Director, Major Infrastructure Assessments
NSW Department of Planning and Infrastructure (SSI_5414)
GPO Box 39
SYDNEY NSW 2001

Subject: Response to Environmental Impact Statement Stage 2 - Stations, Rail Infrastructure and Systems

Proponent: Transport for New South Wales (TfNSW)

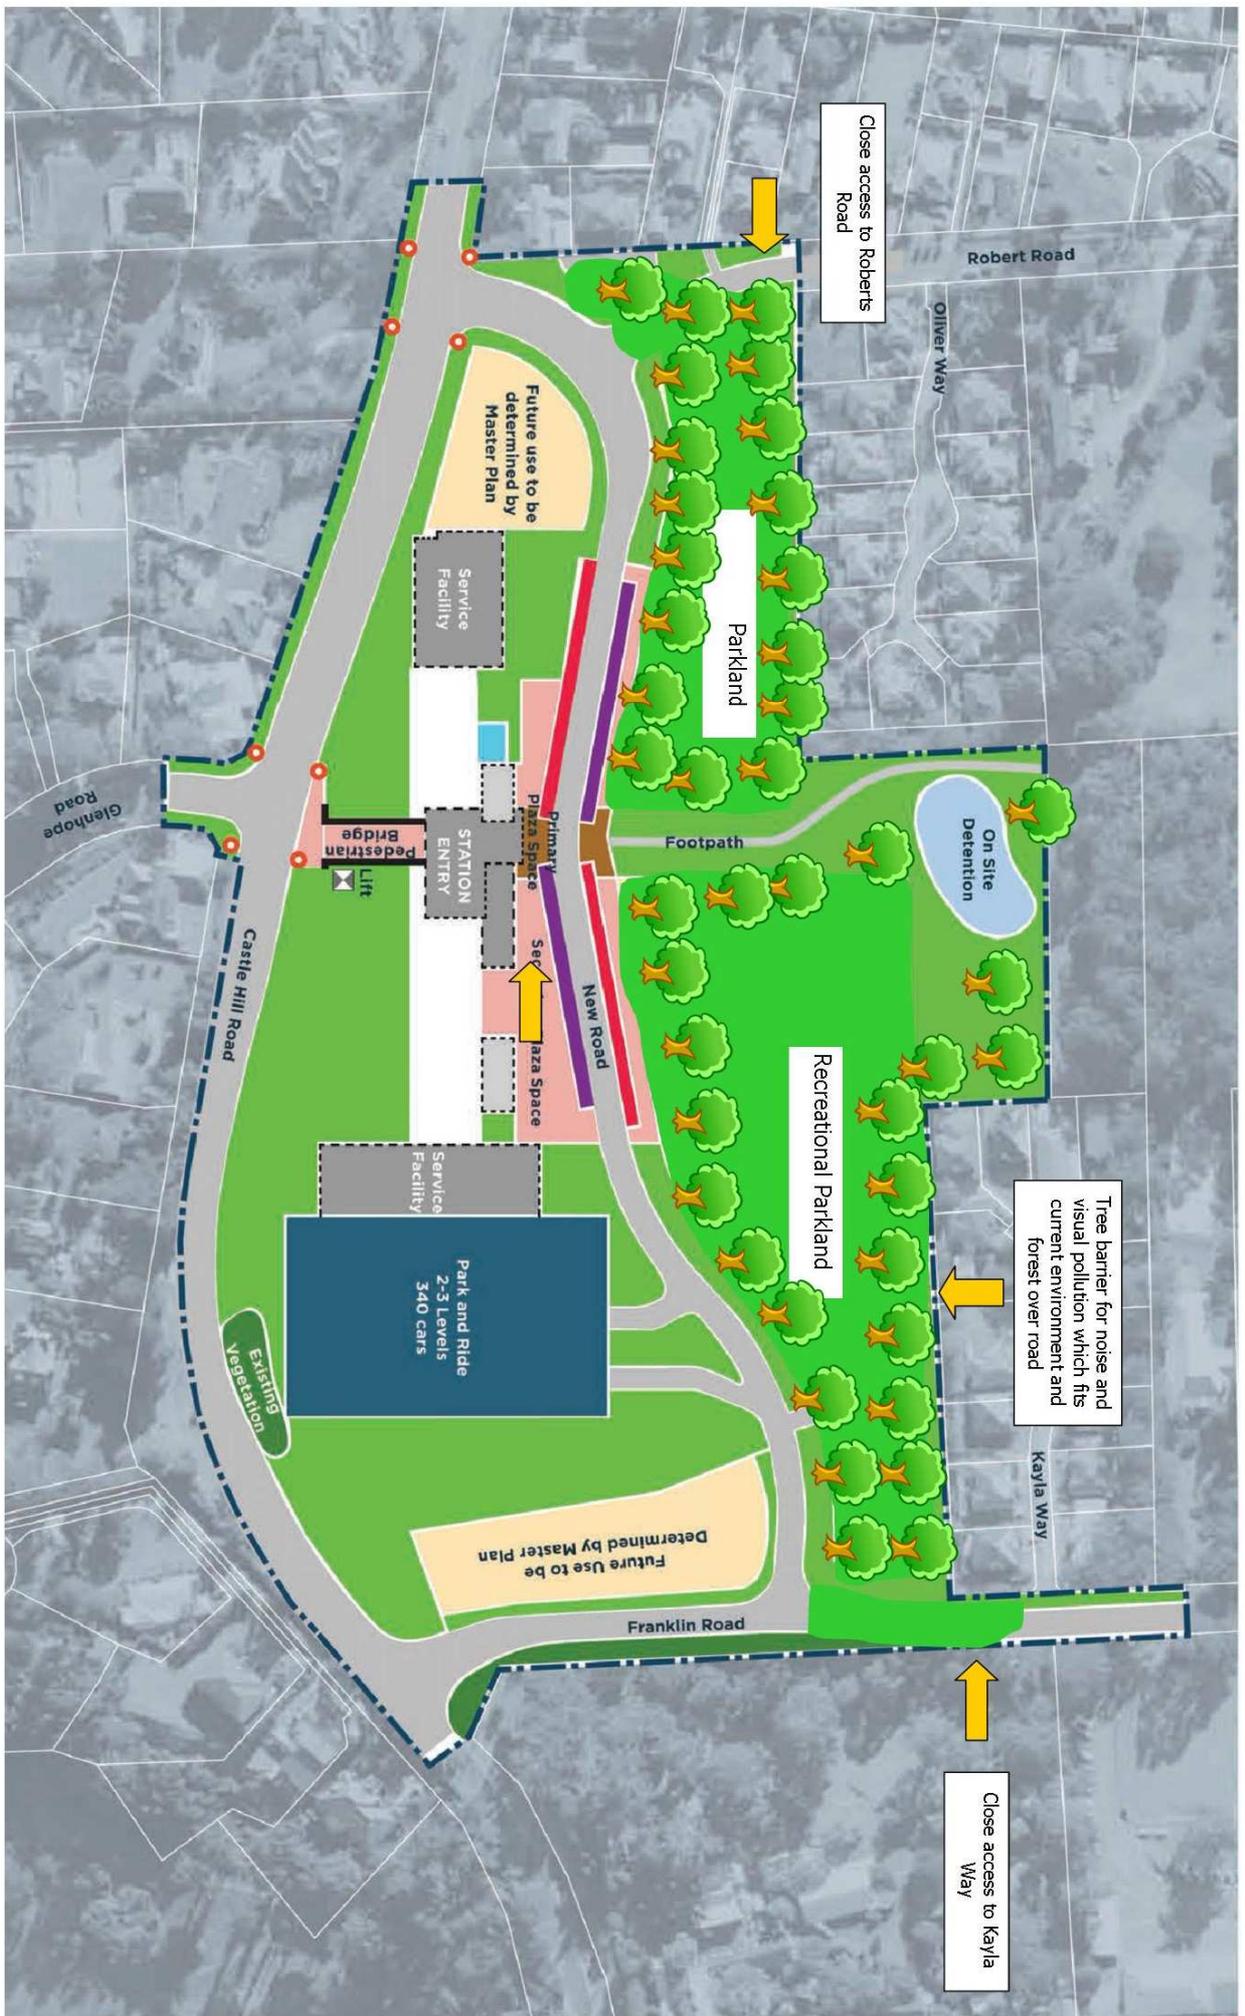
Close access to Roberts Road

Tree barrier for noise and visual pollution which fits current environment and forest over road

Close access to Kayla Way
